Didsbury Point

Amendments Workbook

Project name: Didsbury Point
Project number: 8845
Client: Southway Devco

Further to pre-application discussions with the Local Planning Authority, this booklet has been produced to illustrate amendments made to the consented residential development; Didsbury Point (planning application ref. 135235/FO/2022) as the scheme has progressed to construction stage.

East Elevation

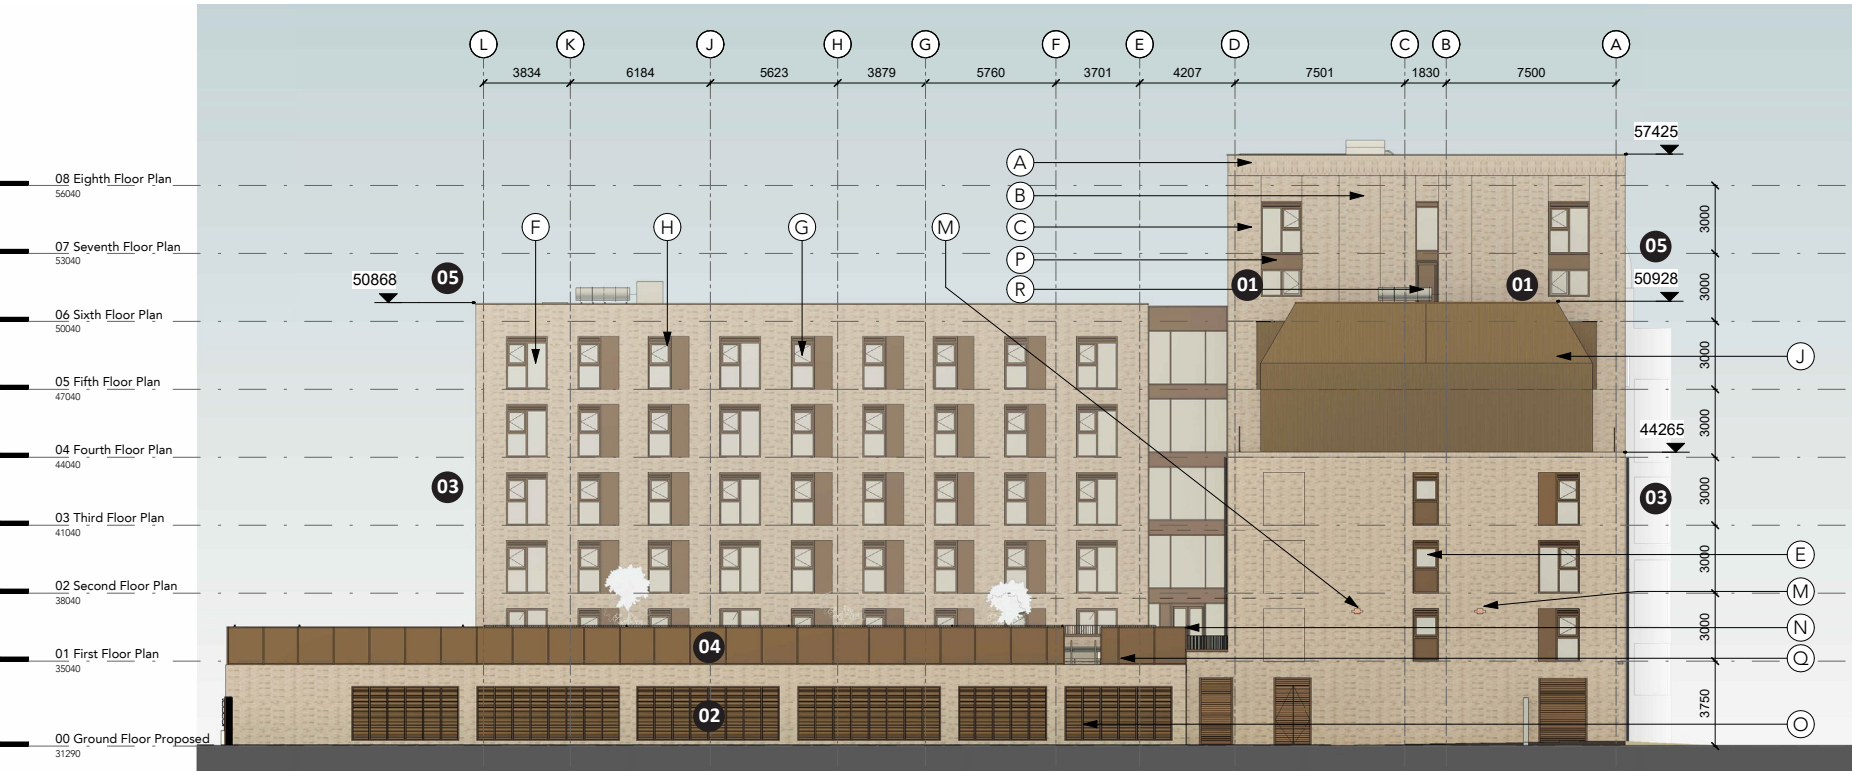
- 01. Window height reduced
- 02. Car park podium materiality changed to alternating louvred screens and brick piers
- 03. All window structural opening heights increased by 75mm and transom proportions altered to achieve height of 1100mm from FFL
- 04. Car park green wall removed
- 05. Lower block heights increased by 225, 268 or 995mm
- 06. Position of ramp to car park altered.
- 07. Changes to louvred screens to ground floor

North Elevation

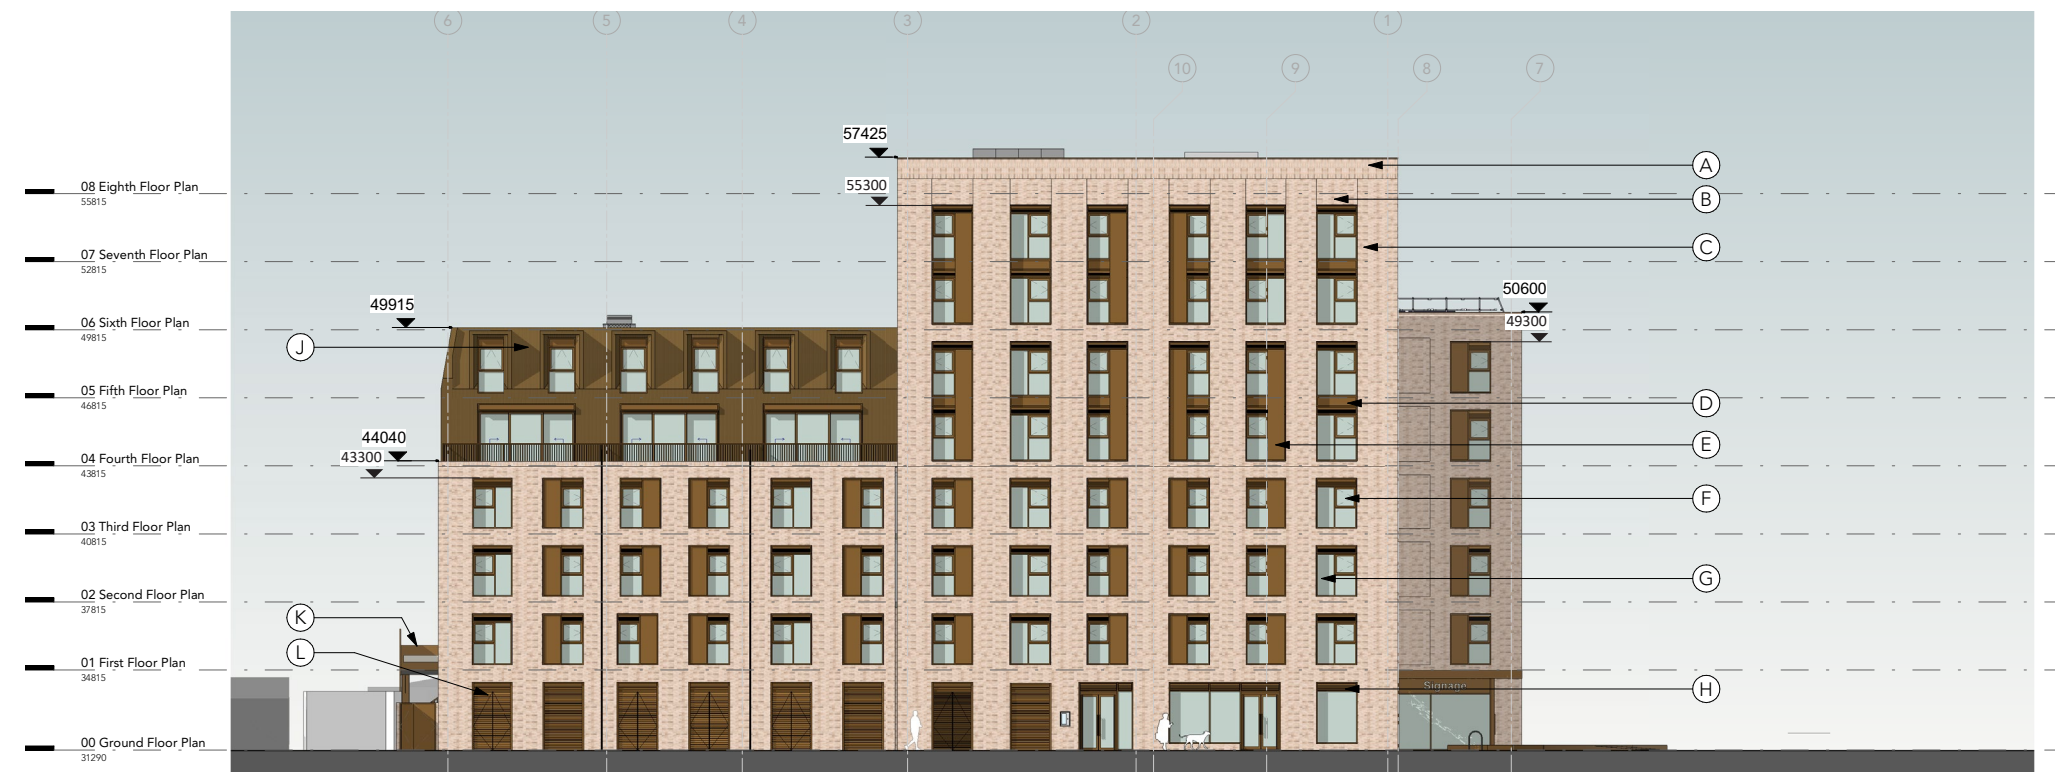
03. All window structural opening heights increased by 75mm and transom proportions altered to achieve height of 1100mm from FFL

05. Lower block heights increased by 225, 268 or 995mm

07. Changes to louvred screens to ground floor

South Elevation

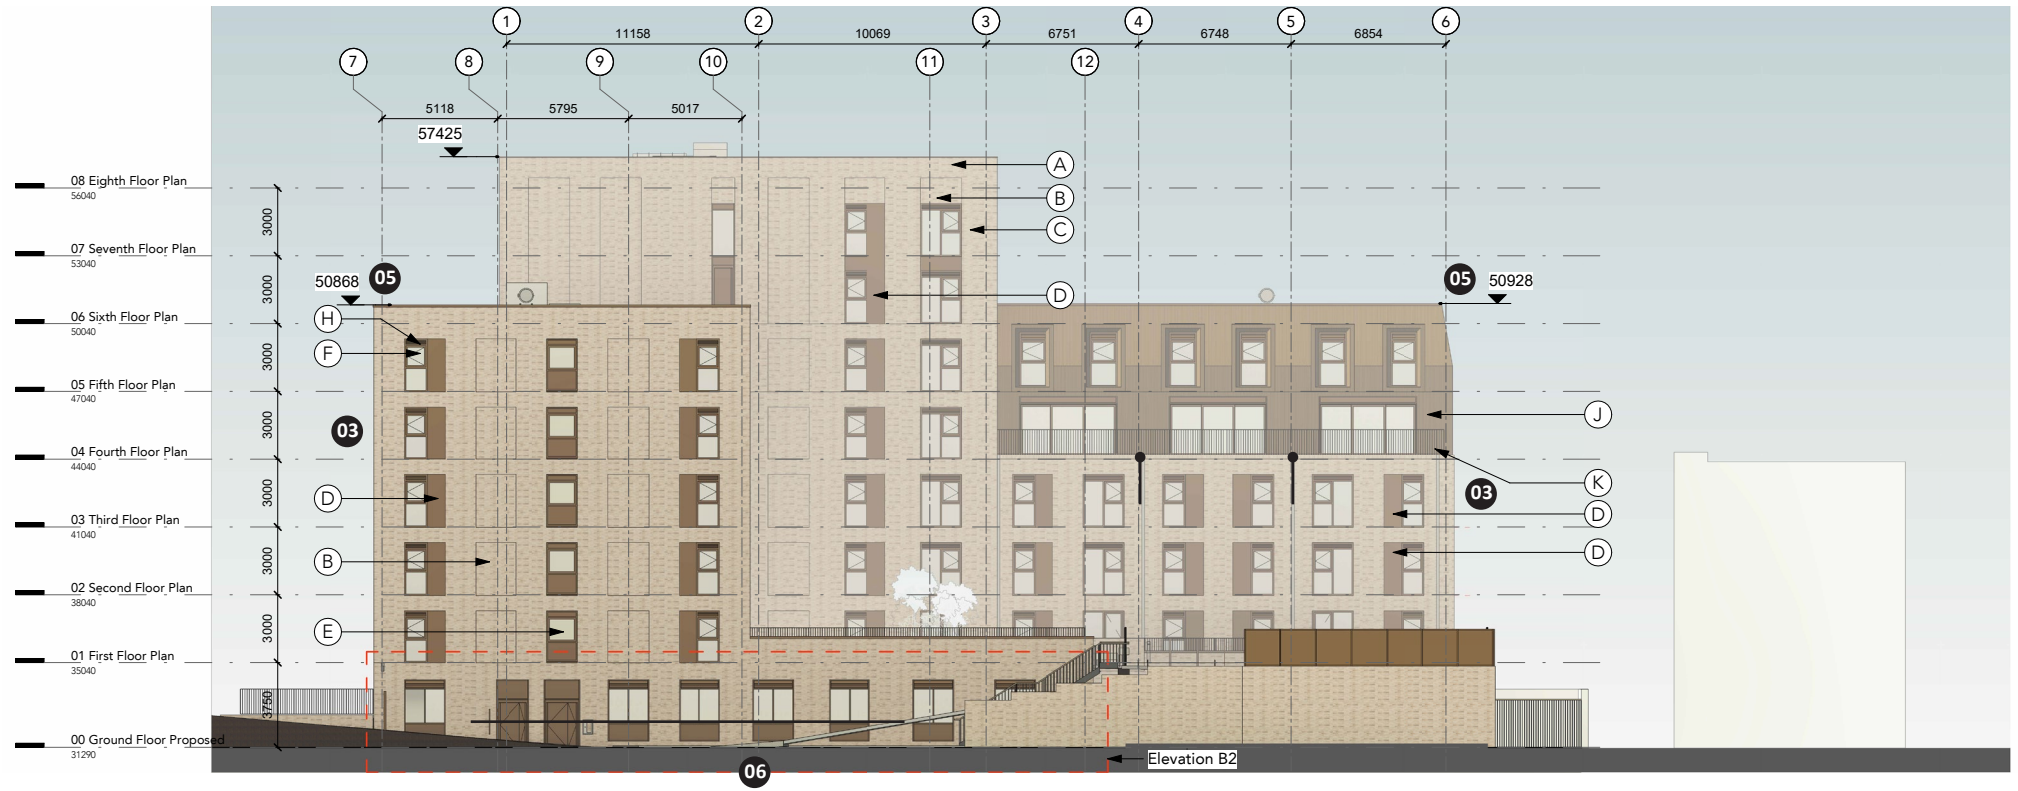
- 03. All window structural opening heights increased by 75mm and transom proportions altered to achieve height of 1100mm from FFL
- 05. Lower block heights increased by 225, 268 or 995mm
- 06. Position of ramp to car park altered.

Ground Floor Plan

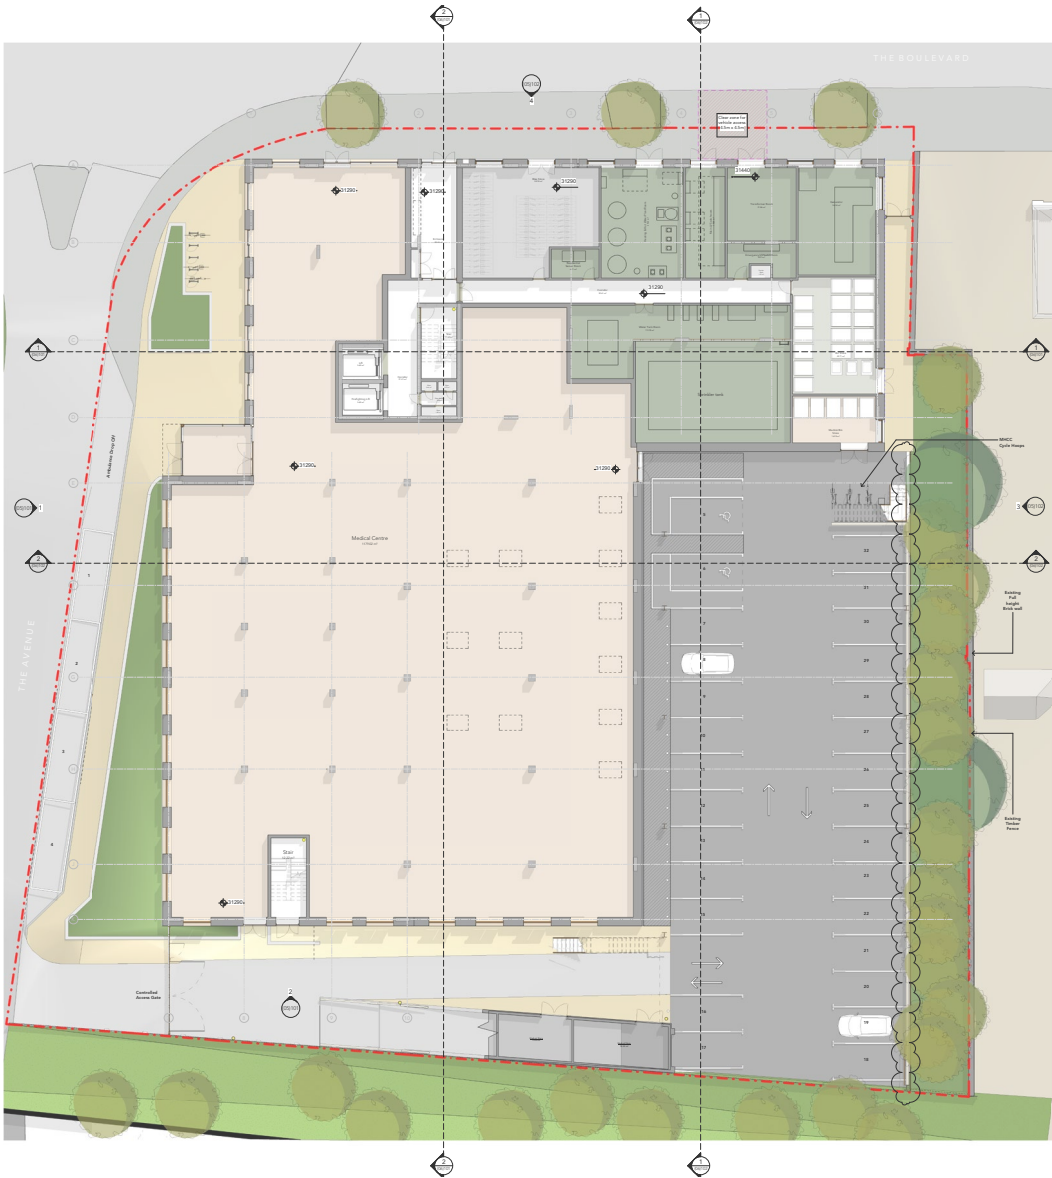
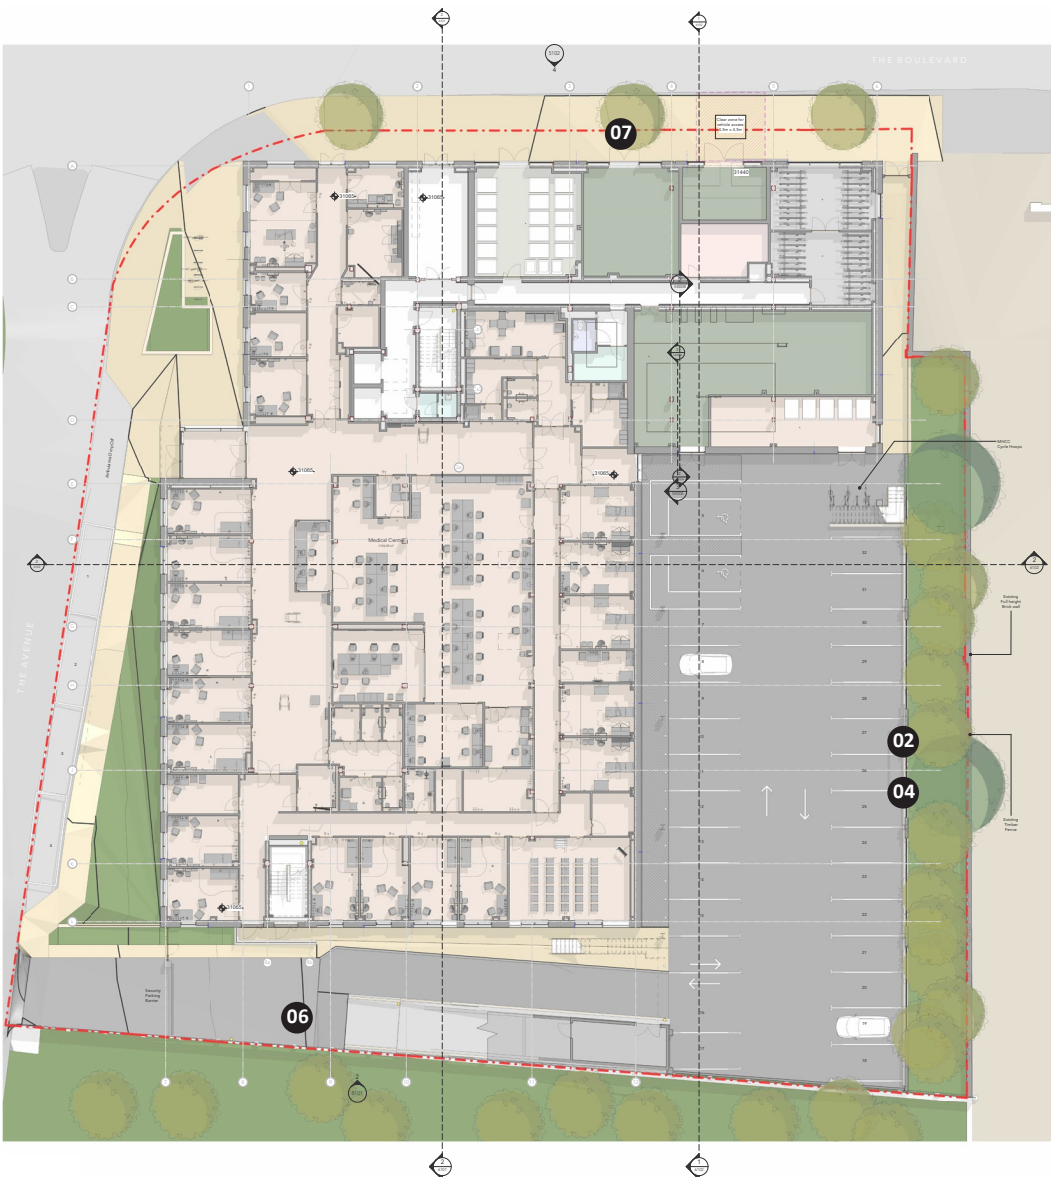
- 02. Car park podium materiality changed to alternating louvred screens and brick piers
- 04. Car park green wall removed
- 06. Position of ramp to car park altered.
- 07. Changes to louvred screens to ground floor

Level 06 - 07 Floor Plan

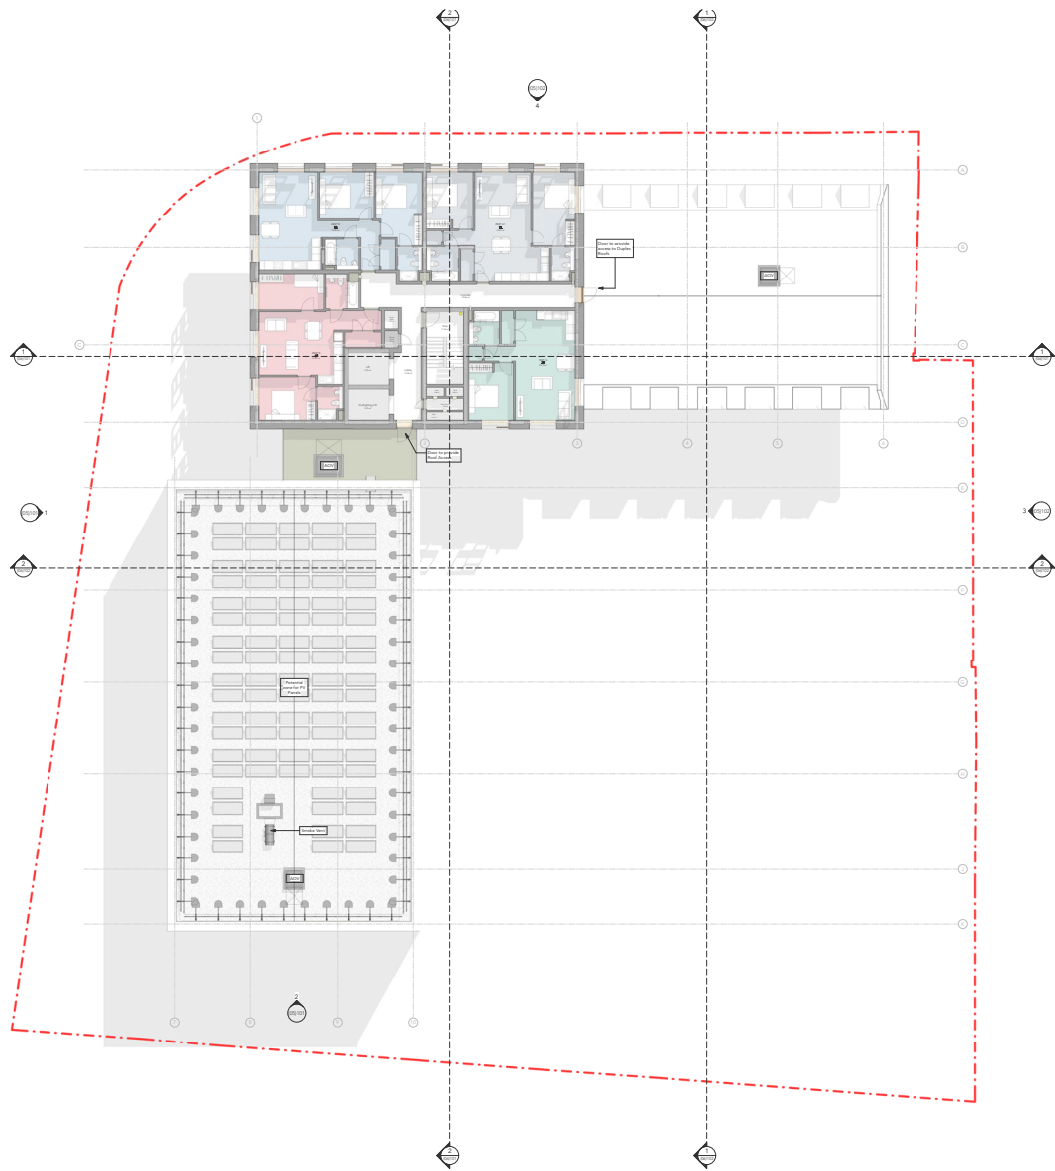
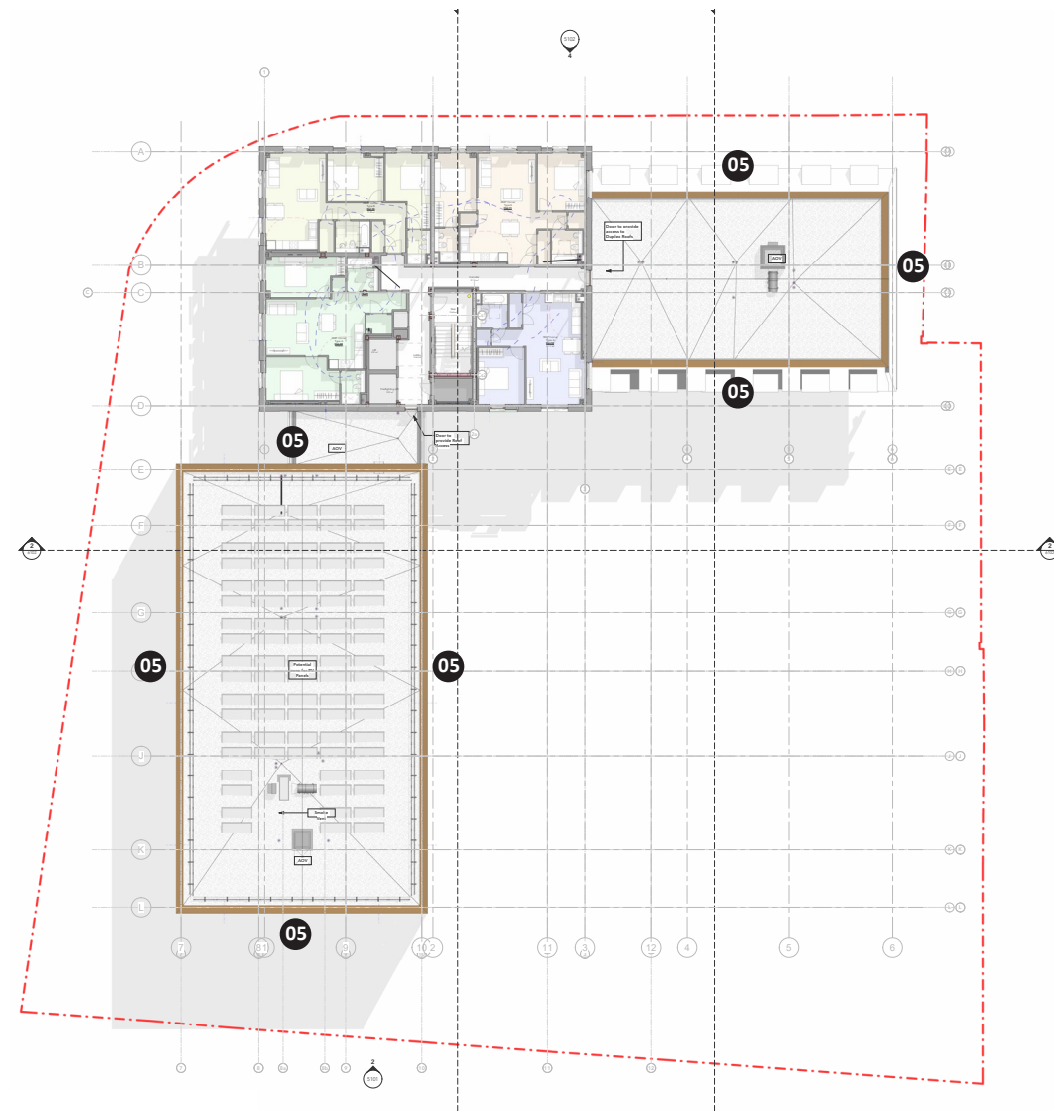
05. Lower block heights increased by 225, 268 or 995mm
